Project: Our Lady of Fatima Catholic School Site Work Chatham, Ontario SCCDSB 619-CP1706

Project ID: ROA16-050

Addendum: 2

Date: May 08, 2017

1-AD2

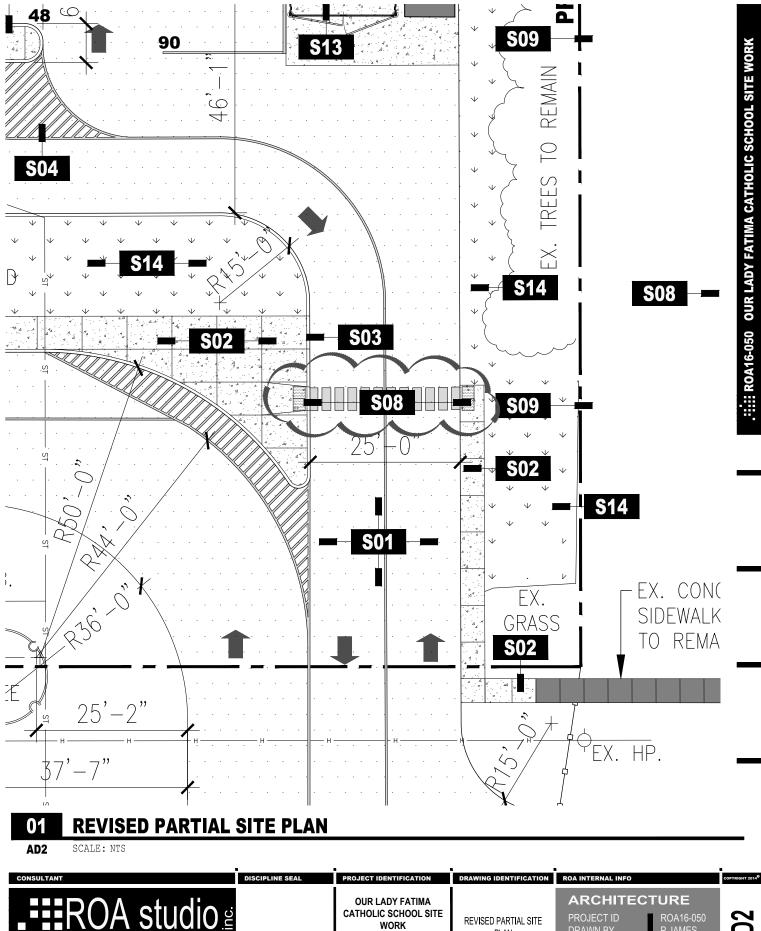
2.2 Refer to Drawing AS101

.1 Clarification: Provide tactile strips as per sketch 1-AD2.
